Town of Parker Community Development Department
Development Review Division
Attention: **Ashley Chasez**

Application Type: **Site Plan**
Status: **First Referral**
Application Name: Crown Point F1 AMD 20 L4E - Land of Sushi
Case/AP#: **SP23-006**
Referral Received: February 21, 2023
Comments Due: March 21, 2023

Review date: **March 16, 2023**
Plan reviewer: **Randall L. Capra**, rcapra@parkeronline.org
Phone: 303.805.3169

TOWN OF PARKER - FIRE/LIFE SAFETY:	C REVIEWED FOR CODE COMPLIANCE w/COMMENTS
---	--

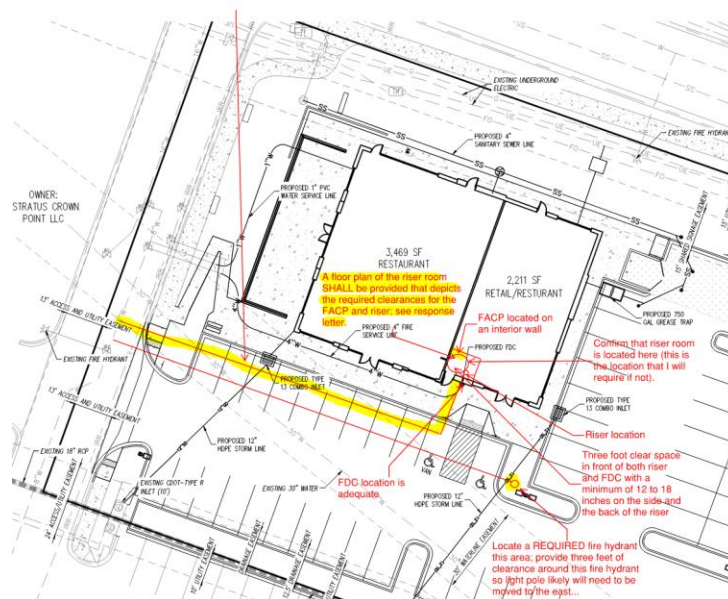
2. During the pre-application meetings, the need to provide a fire hydrant on site... this was not addressed. A fire hydrant will be required at the s/e island by the s/e corner of the building. See the redlined drawings and the detail below for the location of the required fire hydrant. *Satisfied; applicant noted or acknowledged or addressed with second submittal.*

- 3a. **Not Satisfied; the fire hydrant, while located correctly, is shown to have a 45-degree bend in the line. Typically, bends are not allowed. Work through this issue with Cottonwood Water and address when resubmitting. Satisfied with the fourth submittal.**
4. The overall utility plan shall be modified to address the addition of the required fire hydrant as well as relocate the UFL as shown below; address this issue when resubmitting: *Satisfied; applicant noted or acknowledged or addressed with second submittal.*

Many issues with current fire line location; the major issue being that multiple bends in the line (that can be eliminated by relocating to the area highlighted in yellow). Identify the length as well as the diameter (measured from the T at the water main to the flange in the bldg) on the plans (not a note on the side).

Note - ductile iron does not come with a radius... and if it did, a thrust block would be required everywhere water flow changes direction. The area shown in yellow would require three thrust blocks as opposed to seven thrust blocks with the proposed configuration.

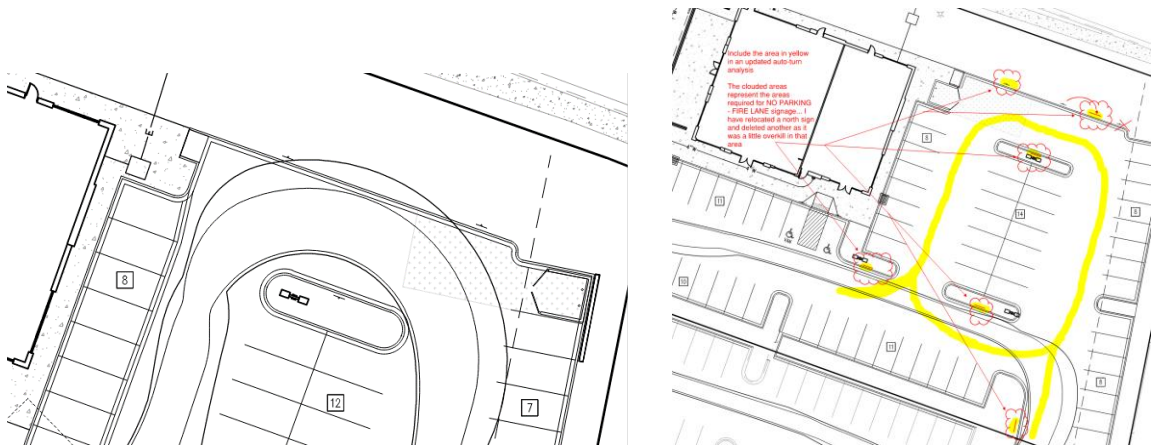
6. The Town of Parker requires that fire apparatus access roads meet the clear-width and weight-bearing standards of the jurisdiction in which the project is located. Roadways shall be designed to support the imposed weight of fire apparatus, 30-ton, two axle and 40-ton three, axle vehicles. An unimpeded clear width of 20-feet shall be maintained at all times as well as the required 28' clear width along the western portion of the building. As such, any location where parked vehicles would obstruct this clear width requirement will require "NO PARKING – FIRE LANE" signage. *This signage shall be red on white. Update design criteria has been provided at the end of this document; ensure compliance when resubmitting. **Satisfied; applicant noted or acknowledged or addressed with second submittal.***

7. While the applicant has provided an auto turn analysis, the applicant has not addressed the access on the eastern portion of the site. When resubmitting, the applicant shall provide an auto turn analysis indicating that apparatus can **navigate all portions** of this site (east side of the building); NO PARKING – FIRE LANE signage is required for any portion of the access where the 20-foot clear width requirement cannot be met. See below for the areas **required** to be included in the auto turn analysis (in addition to what already has been shown) and address when resubmitting: *Not satisfied; applicant has provided the required area for the analysis though the auto turn shows quite a bit of encroachment into the landscaping on the north end. Clean up the analysis to ensure access when resubmitting. **Not satisfied with the third submittal; the applicant may need to remove a couple of parking places on the east side of the parking lot to make the REQUIRED auto-turn analysis work more efficiently. Currently, the analysis indicates that apparatus would need to navigate into parking stalls to make the proposal work. The analysis also does not take into consideration extended cab pickup trucks and vans that would hang out into the required access. Address this issue when resubmitting. Satisfied with the fourth submittal.***
